SERVICE BULLETIN

NO. ARC 852-004

ARC STC SA00555DE, tire/fairing interference during landing gear retraction.

PA-31-350 Chieftain, when Boundary Layer STC SA00202SE is installed.

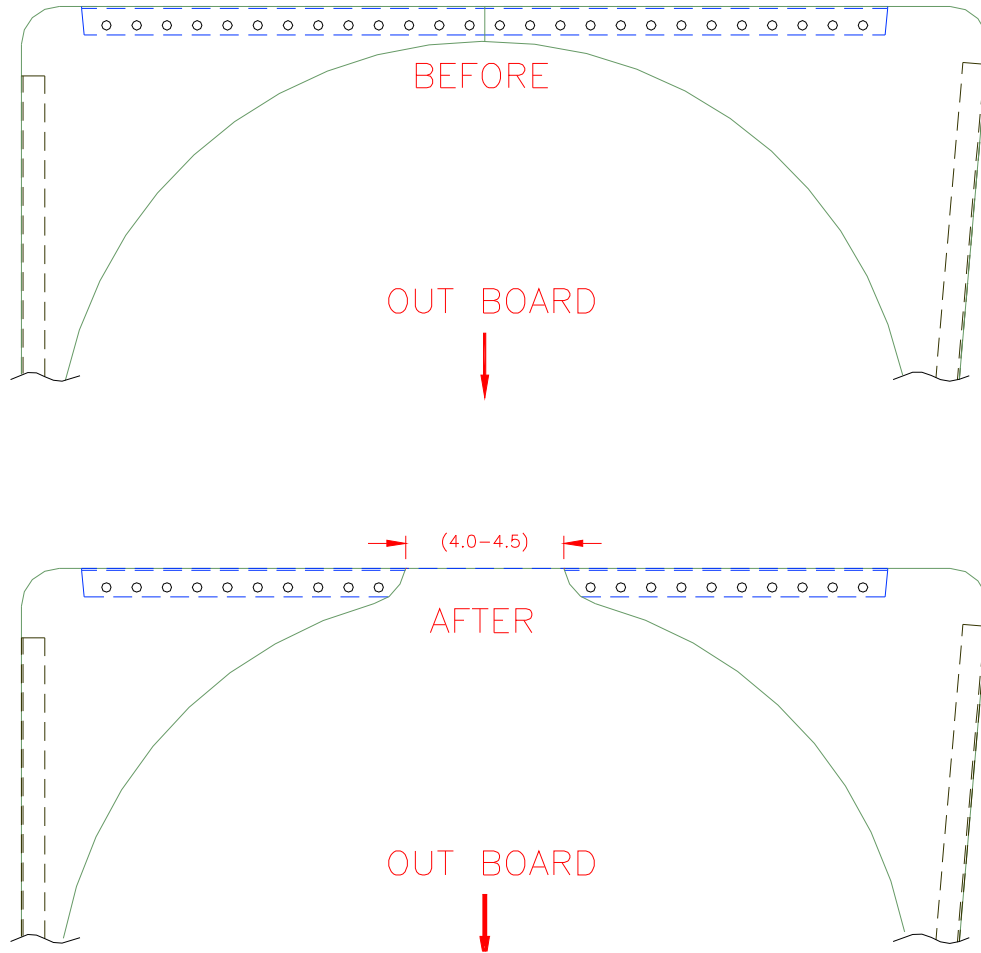
When STC SA00202SE is installed on the PA-31-350 Chieftain, where the new longer style torque links are installed the MLG strut extends approximately ½ inch longer out of the strut housing assembly. This extension allows the tire to contact the new fairing when the landing gear is retracted at its inboard location. This document provides a means to further modify the affected area by cutting the fairing closer to the inboard wheel well rib to provide the required tire/fairing edge distance.

If your airplane has STC SA00202SE installed it will be necessary to provide additional clearance to the inboard wheel well fairing by increasing the new fairing diameter closer to the inboard rib in accordance with the Installation Procedures, Step 13, and the attached diagram.
